# CITY OF ALBUQUERQUE

**RE: Lot 17 Block 1 Volcano Cliffs Unit 22 SAD 228  
8015 Agua Fria Ct. NW  
Grading and Drainage Plan  
Engineers Stamp Date: 10/19/2020 (D10D003N17)  
CO Certification Date: 3/11/2021**

## DRAINAGE AND TRANSPORTATION INFORMATION SHEET (REV 11/2018)

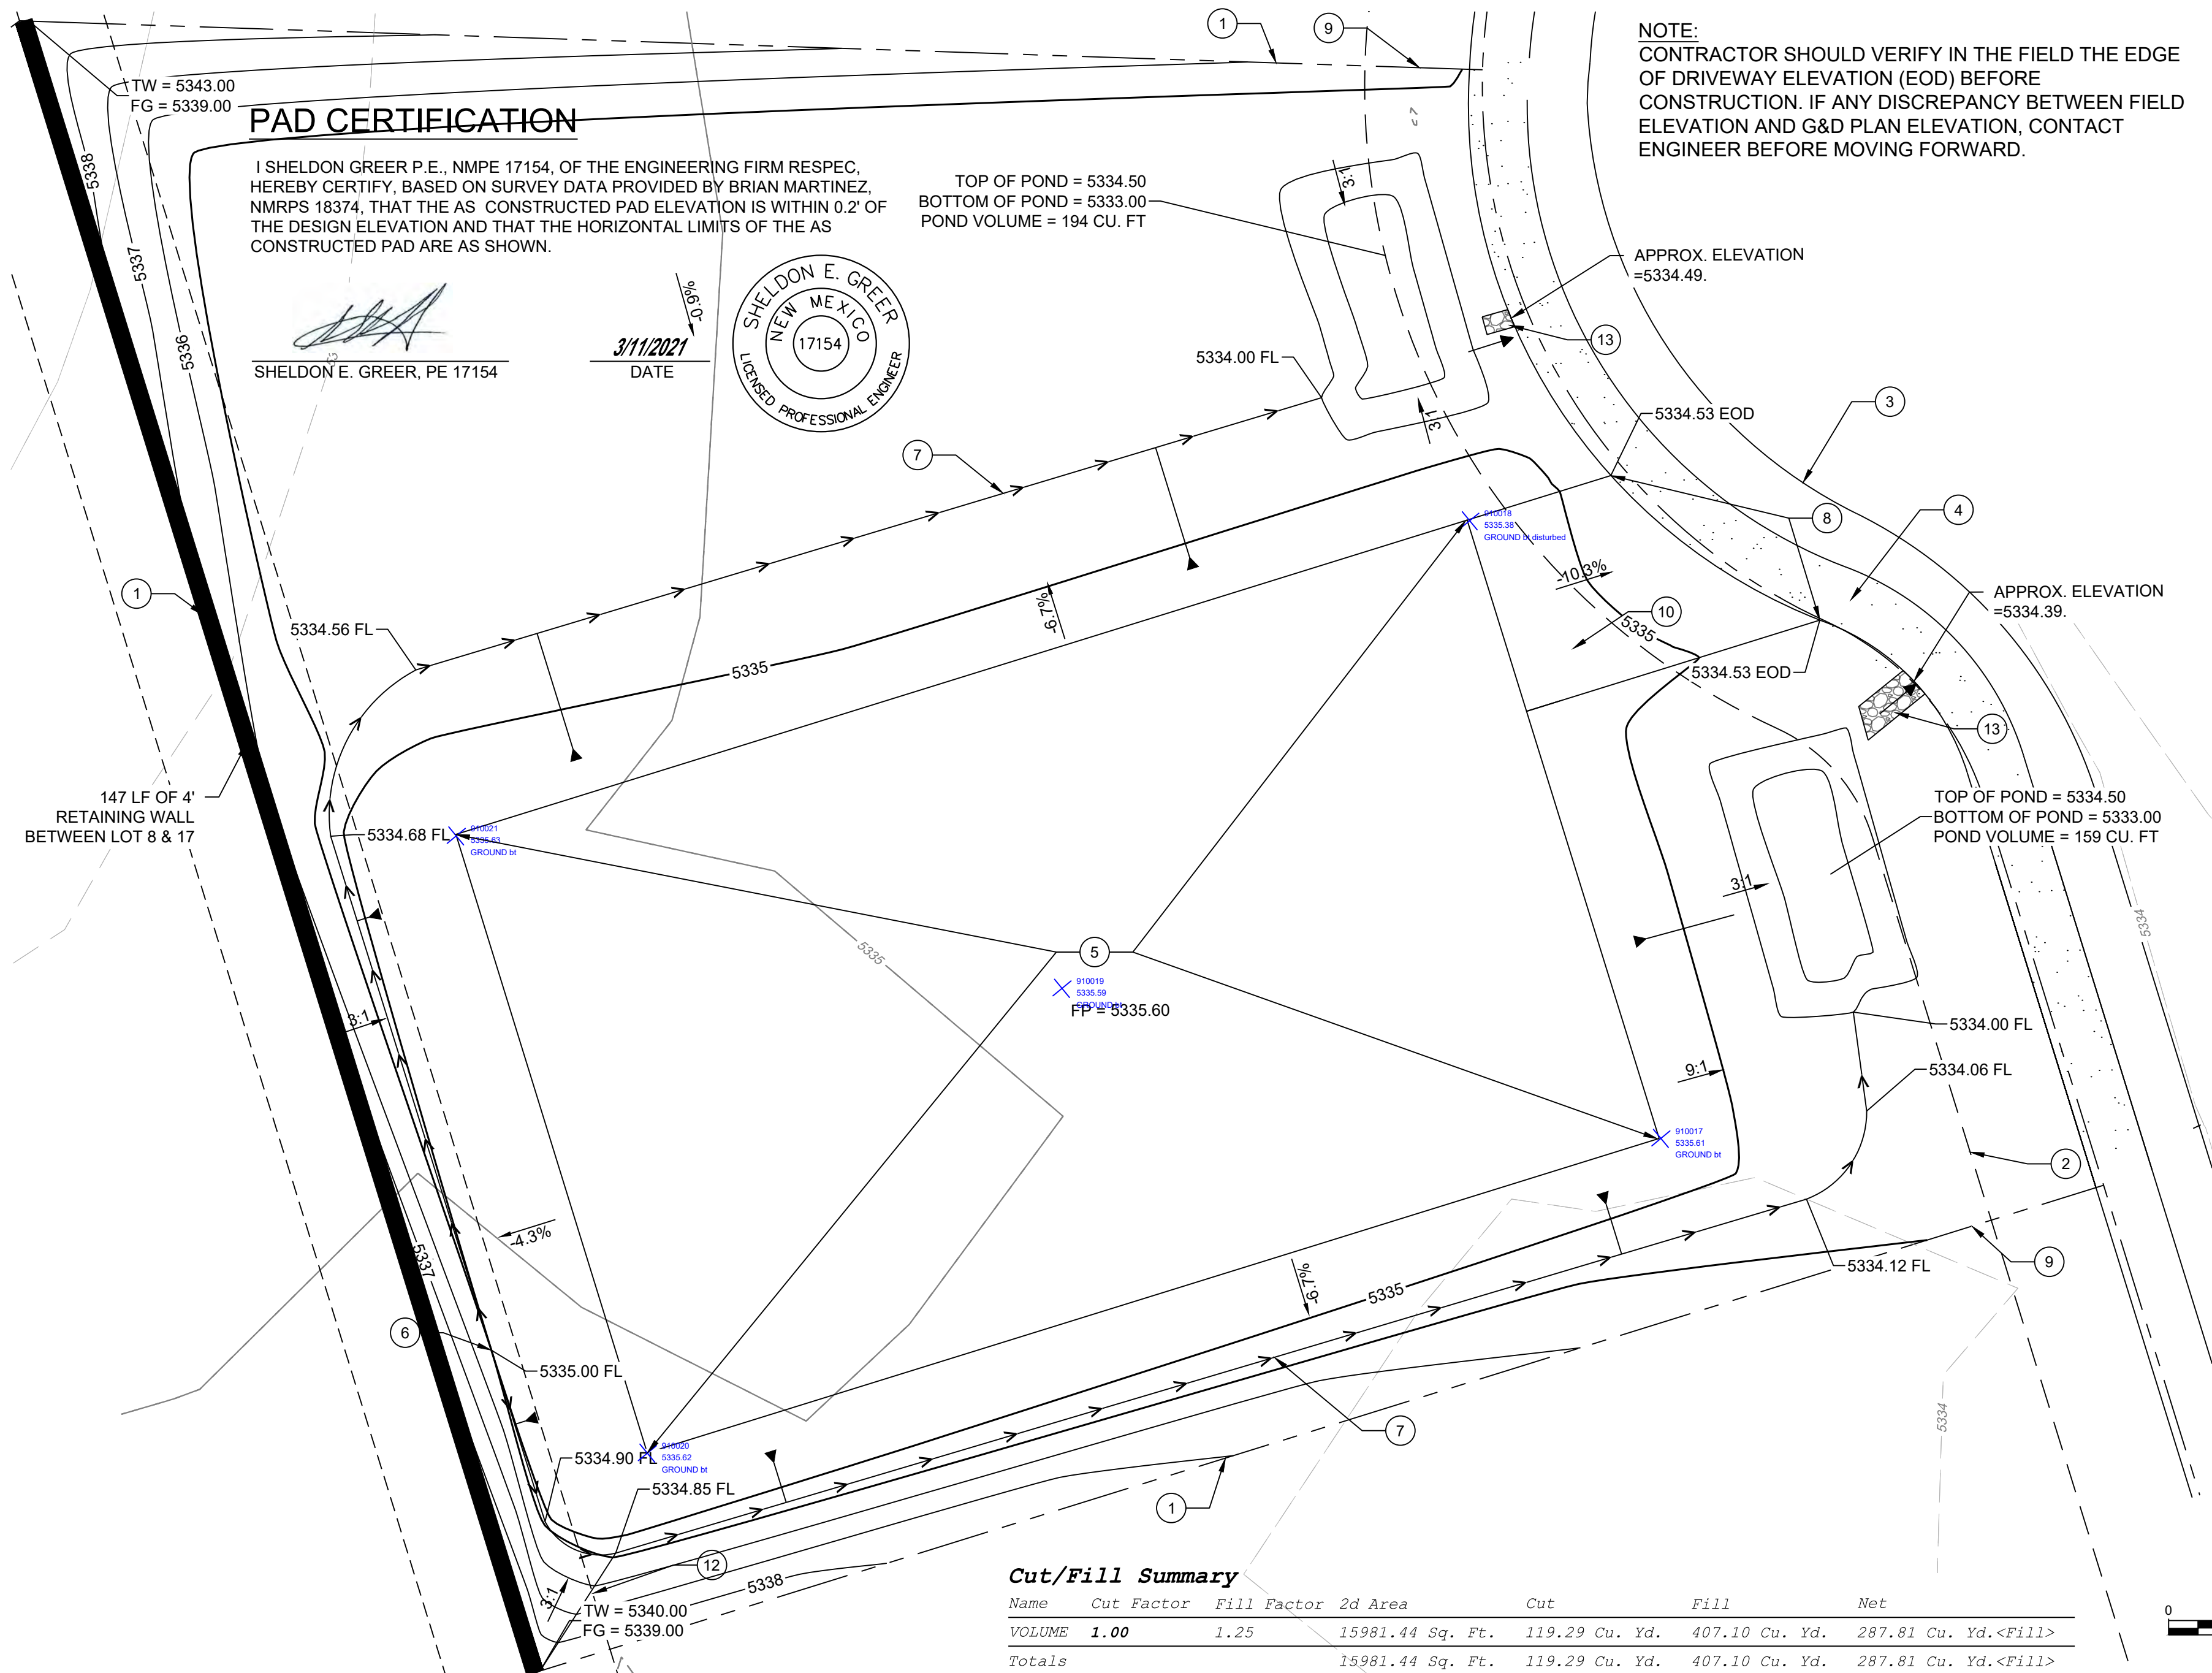
Based upon the information provided in your submittal received 3/22/2021, this plan cannot be approved for Building Permit until the following comments are addressed.

- Lot did not have an address, provide address
- Have all dirt ramps removed from the streets. Crusher fines or lumber are to be used for driving over a curb.
